**BARTLETT REGIONAL HOSPITAL BEHAVIORAL HEALTH FACILITY  
Contract No. BE21-149**

**ADDENDUM NO.: FOUR**

**March 12, 2021**

## TYPICAL THICKENED SLAB EDGE

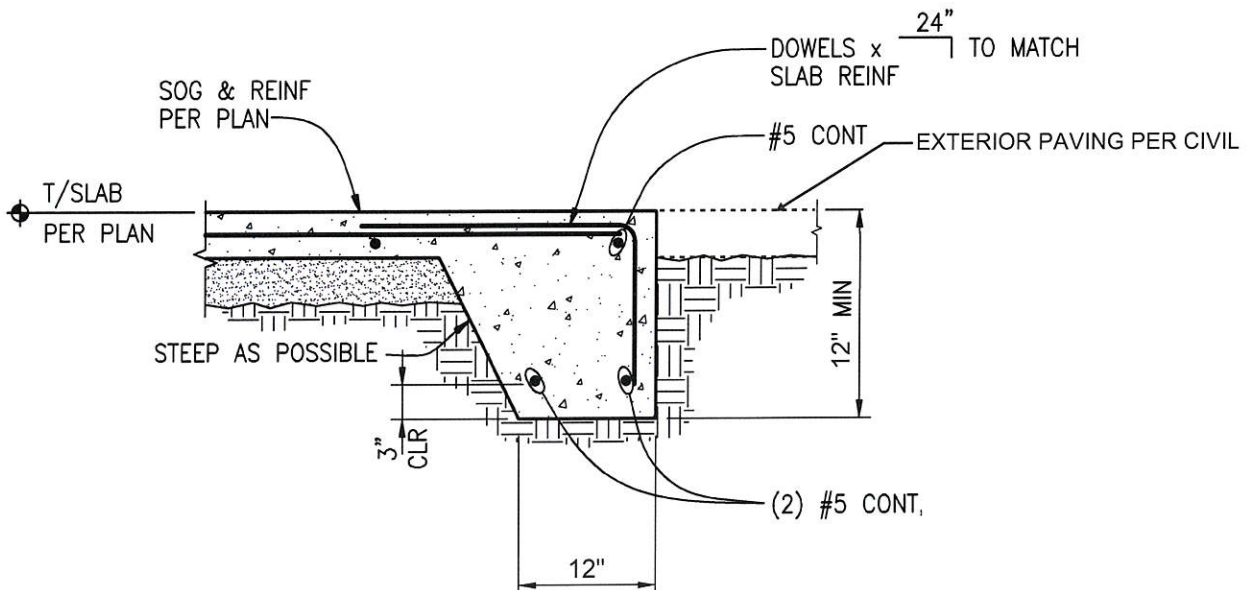
Item No. 6 Sheet S3.2, titled “STRUCTURAL FOUNDATION DETAILS”, details: **Add** thickened slab edge detail for use at all exposed slab on grade edges associated with Level 0 Parking 001 including at the garage vehicle entry on Grid 1 from Grid B to Grid D, and at (3) sides of the parking overrun slab originating on Grid A and extending approximately 8’ south of Grid A. See attached Structural Sketch SKA-1.
